<u>Definitive Subdivision</u>: Two existing lots on an unaccepted stretch of Lincoln Drive and Jason Terrace.

- Applicant: Seaport Homes LLC
- Owner: Roger & Jeanine Jason
- Agent: Farland Engineering
- Project Location: Map 30A, Lots 85N and 85M. The site is near the terminus of Route 240 north of Route 6 at the end of Lincoln Drive (accepted street) and Jason Terrace (an unaccepted street).
- **Proposal:** The proposal is to create two buildable lots and create a road standard by connecting the paper street between Lincoln Drive and Jason Terrace to be known as Rita's Way.
- **Zoning:** Single Residence District (RA). 15,000 sf minimum lot size with 100 feet of frontage.
- Surrounding Land Uses: Highway, Commercial and Residential.

— 2-LOT DEFINITIVE SUBDIVISION-A SEAPORT HOMES DEVELOPMENT

Lincoln/Jason Definitive Subdivision

GRADING AND UTILITIES

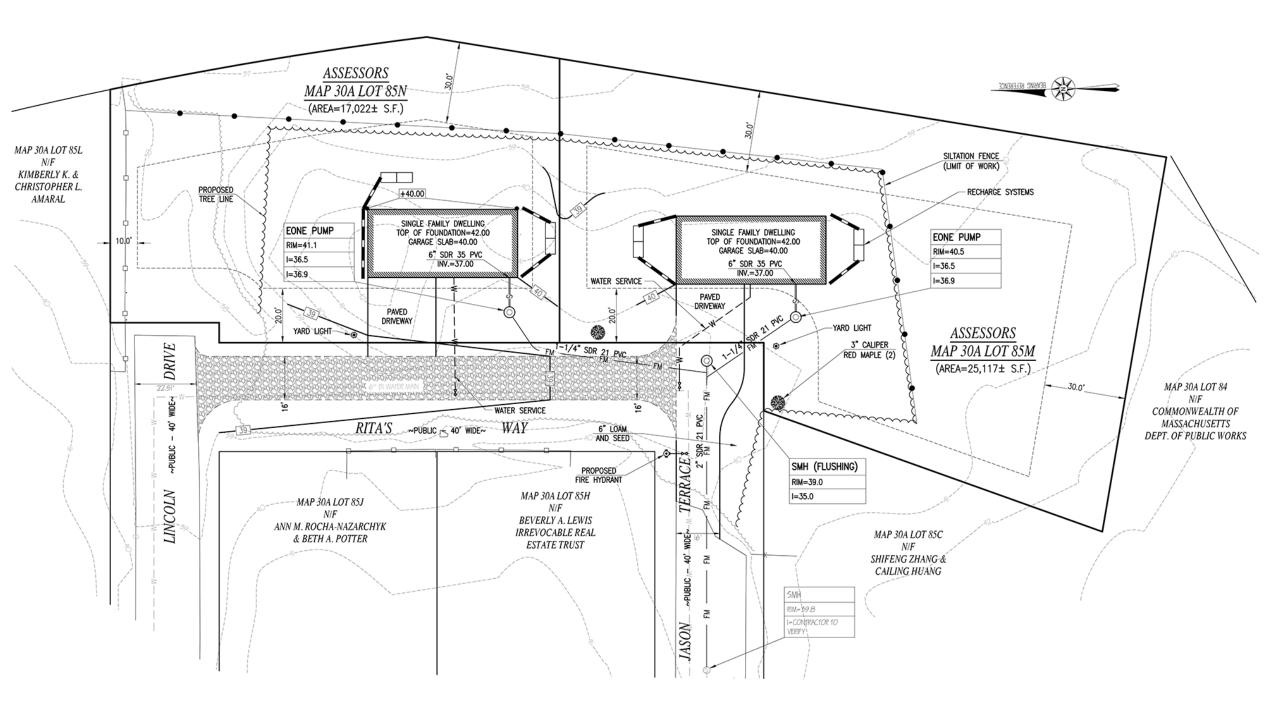
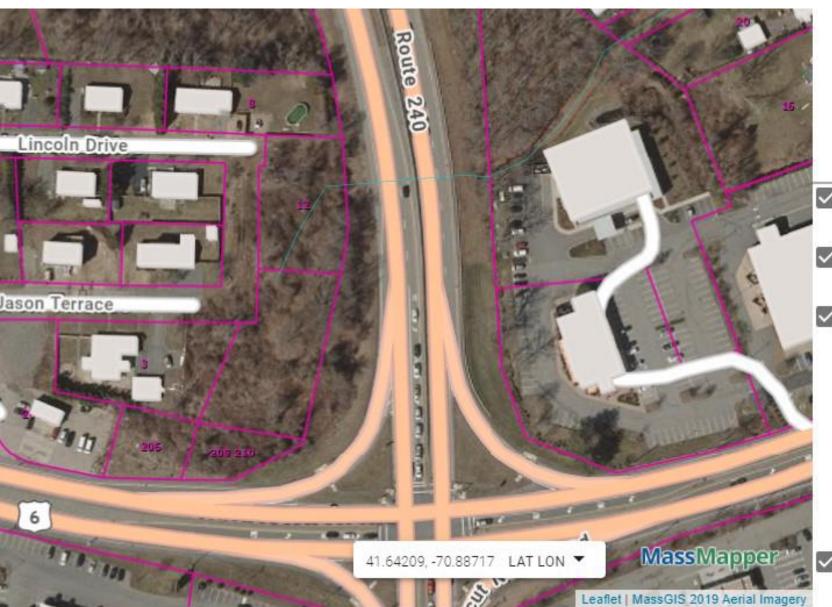
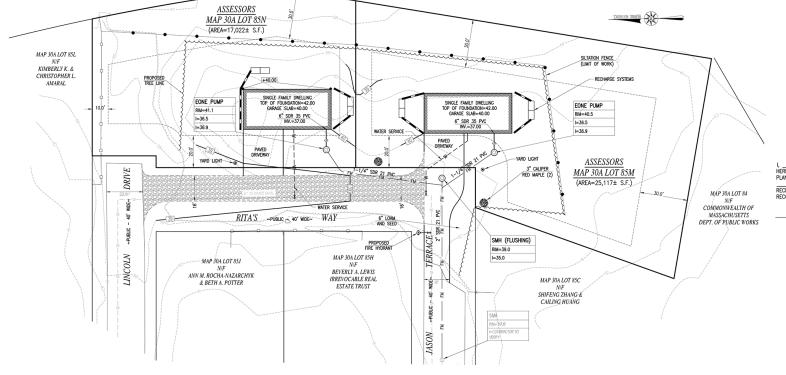
- <u>Water</u>: The water department would like to have service at the end of Jason relocated so it does not cross under the driveway. They would also like the location of the water main on Rita's way verified of its location to make sure it is in the right of way.

- Contour lines/ spot elevations provided do not clearly show where storm water runoff will go or collect. Profiles are requested to supplement.
- Lines coming off recharge system are not identified, no detail provided on sheet 6 of 6 Yard lights shown with no detail or information.

- No detail provided for water connection or hydrant install.
- Gravel road request denied, remove gravel roadway cross section.
- Roadway cross section showing grass strip pitching towards the roadway, this contradicts the waiver request for curbing as water is requested to sheet flow off the roadway. Revised and update accordingly.

- Permanent trenching detail not provided for utility work. Permanent utility patch must be 3.5" minimum or match thickness of the existing asphalt plus 1 inch.
